Project EnergyConnect - South Australia component

# **REVIEW OF ASPECTS OF ELECTRANET'S CONTINGENT PROJECT APPLICATION**

Report prepared for:  
**AUSTRALIAN ENERGY  
REGULATOR**  
December 2020

Figure 4.2: Profile of resource effort by activity, Nov 2020 – FTE/month

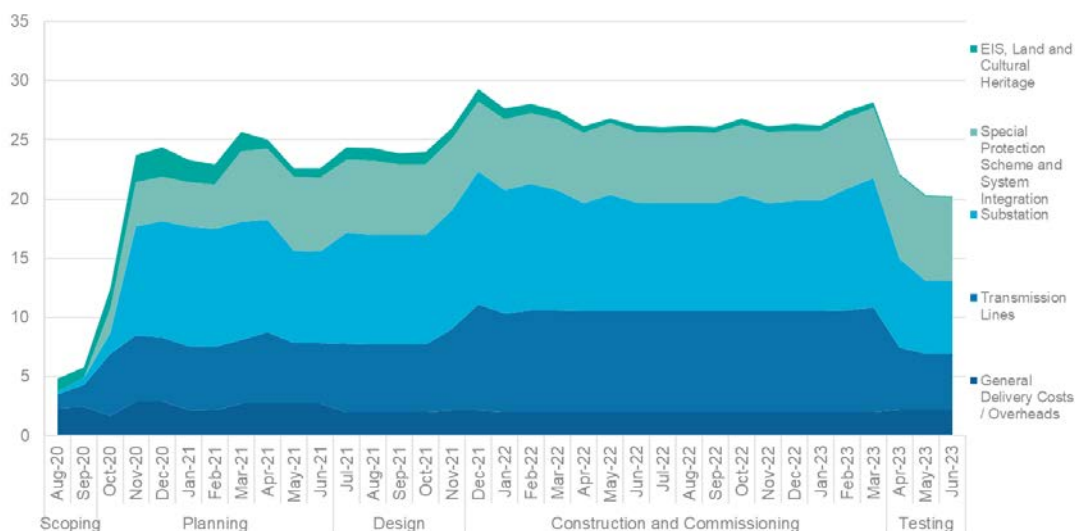
204. It is clearly evident from the above charts, that the resource effort has been shifted forward with a greater amount of time incurred in the early phases of the project – including the planning and design phases. Of most significance is the change in resource profile in the final stages of the project. Previously ElectraNet retained a smaller project team over a longer period associated with the inter-network testing tasks whereas in the latest adjustments, this work is completed within 3 months whilst a large part of the project team is retained.

Figure 4.3: Comparison of resource effort – FTE / month

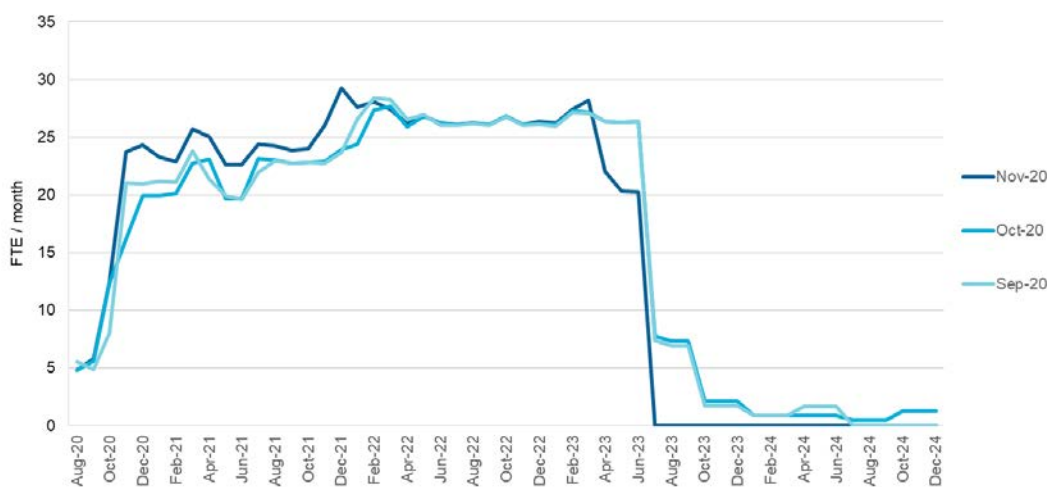
205. ElectraNet has proposed a slightly reduced cost estimate, that does not include any acceleration costs to achieve the earlier completion date.
206. In addition to the change in resource profile illustrated in the above figures, consistent with undertaking early works, we also observe:

Figure 4.4: Summary of changes to resource hours between Oct and Nov 2020 submissions - Hours

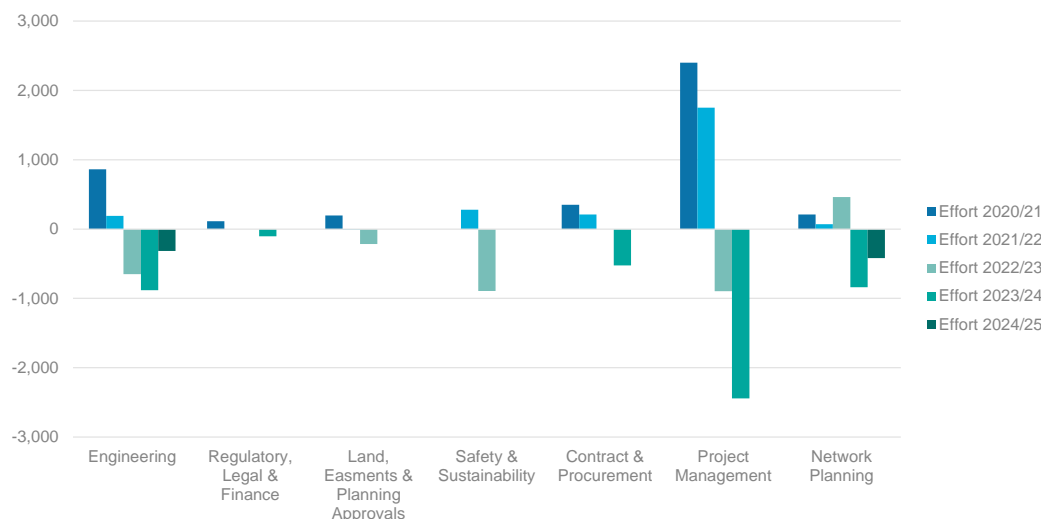
208. The major changes are to reduce the Engineering, Safety & Sustainability, and Network planning hours across the project. For project management, significant effort has been brought-forward with a net increase of 812 hours over the project. As a result of changes in the resource mix, the increase in resource hours results in a net cost reduction for the project compared with the original application.
209. On balance, we consider that the steps included in the adjusted resource profile are indicative of ElectraNet seeking to optimise the composition of the project team to meet the project objectives.
